Our Case Number: ABP-317780-23

Re: Bray to City Centre Core Bus Corridor Scheme Compulsory Purchase Order 2023
Bray to Dublin City Centre

RE: An Bord Pleanala SID Case Reference No KA27.317780

Subject: Bray to Dublin City Centre Core Bus Corridor Scheme Compulsory Purchase Order.

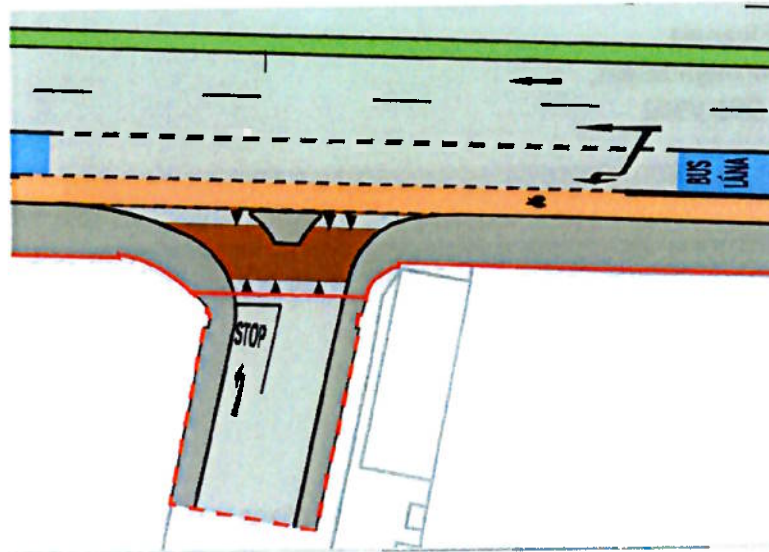
The proposal involves the provision of a **STOP** line at a location within the mouth off the entrance where there is no visibility splay to emerging vehicular traffic due to the obstruction posed by the Lodge on the southern side of the mouth of the roadway, as shown in the extract from SHEET 09 of the Scheme

It is submitted that a view to the right is essential in the particular circumstances of this case where egressing traffic in entering onto a major traffic route which is heavily used at all times.

The proposed design is not in compliance with Chapter 4, Section 4.4.6 of DMURS which advises that a visibility splay should be provided at junctions, as extracted below :

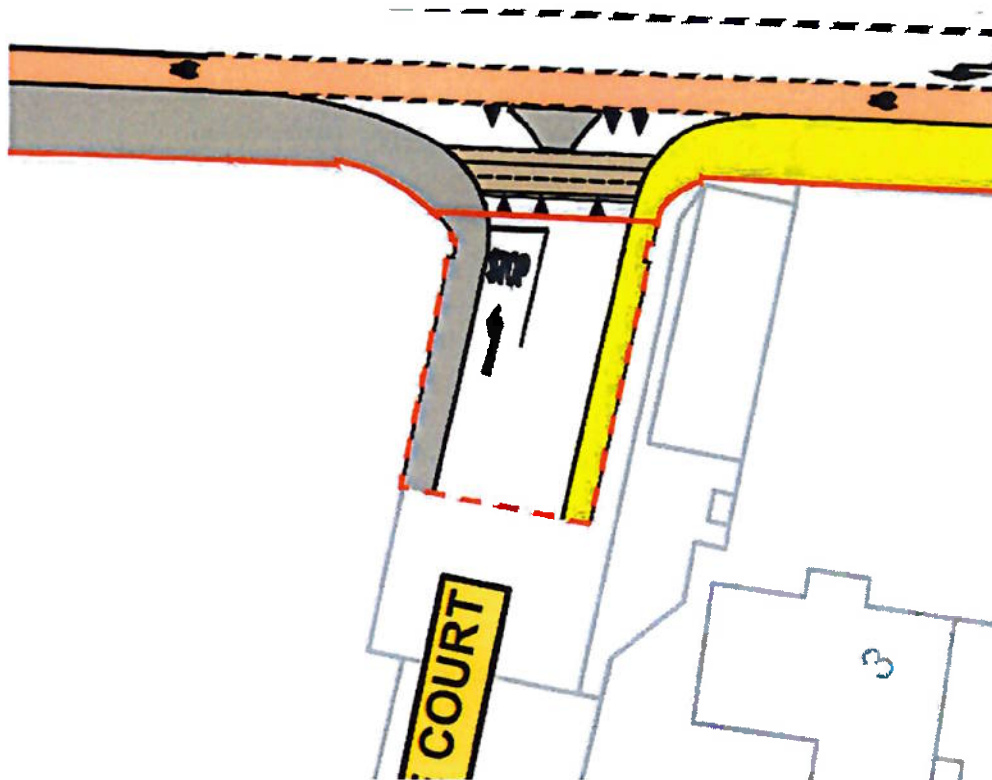
The impact of this structure on the existing junction is shown in the aerial view below, in which the raised pedestrian table is to be located across the full width of the junction and the outer edge will be ramped down to carriageway level on the inner edge of the bicycle lane on the Stillorgan Road.

The provision of a raised table at this location will constitute a significant impediment to the safe use of the junction by ingress and egress traffic.

It is submitted that the provision of this structure is a disproportionate response to the need to facilitate pedestrian crossing requirements at this location.

The above aerial view demonstrates that there are no facilities or amenities within the 400m pedshed radius from the junction. Pedestrian crossing facilities are not provided in the vicinity on the Stillorgan Road.

Accordingly, it can be reasonably concluded that pedestrian travel mode in this area is negligible.

Therefore it is submitted that the use of a raised pedestrian table is not necessary at this location, particularly, where the circumstances cited in DMURS Chapter

4.4.7 for the provision of raised tables do not prevail, and are not advised in the situation which prevails at the junction.

It is submitted that the provision of a courtesy crossing, as outlined in Chapter 4.3.2 of DMURS, and defined by a change in material alone, will be sufficient in the circumstances of this junction to allow pedestrians to informally assert the required degree of priority over drivers.

The impact of the scheme is particularly delineated on SHEET 09 Volume 3 Chapter 4 in respect of Landscape, as extracted below:

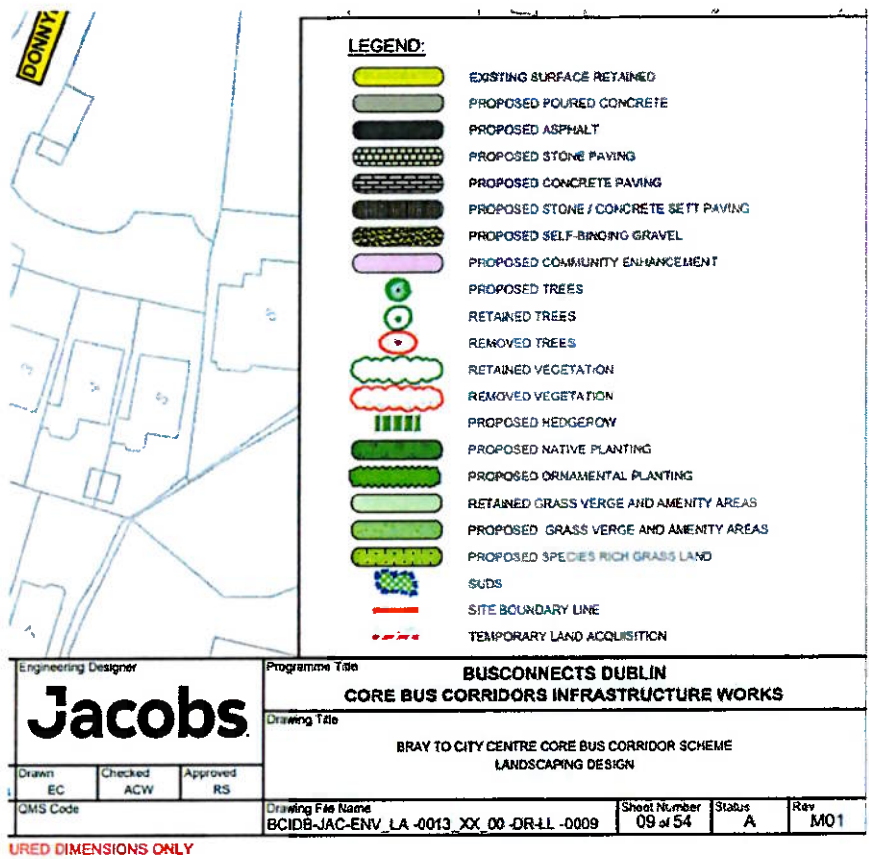
In the first instance, it is to be noted that the layout of the raised pedestrian table is not in agreement with the plan shown in the General Arrangement Section, as abstracted in Section 1 above. It is now shown offline from the 'desire' route, as determined by the existing adjoining footpaths on either side. This layout is contrary to advice in Chapter 4.3.2 of DMURS.

This proposal is further set out in the SHEET 09 Pavement Treatment Plan, abstracted below:

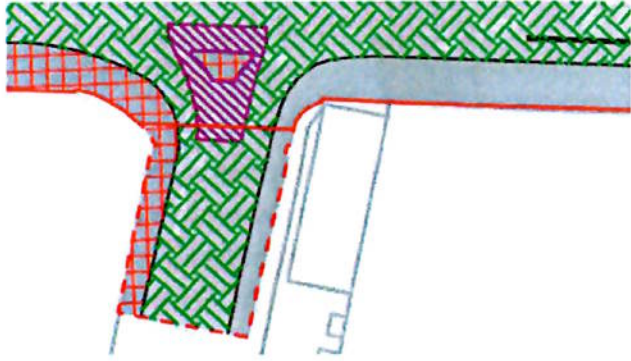
that the existing footpath surface to the south of the junction, and extending into the junction, is denoted as 'existing surface retained'.

However, the footpath surface to the north of the junction, including that extending into the junction is to be replaced with 'proposed poured concrete'.

It is clear that the entire area of the 'temporarily acquired' lands are to receive a 'proposed overlay'.

It is submitted that the existing internal footpaths on either side of the junction are in similar satisfactory condition .

The partial renewal of surfaces, as proposed under this scheme, will have a negative impact on the appearance of the entrance to the development and will detract from the value of the property.
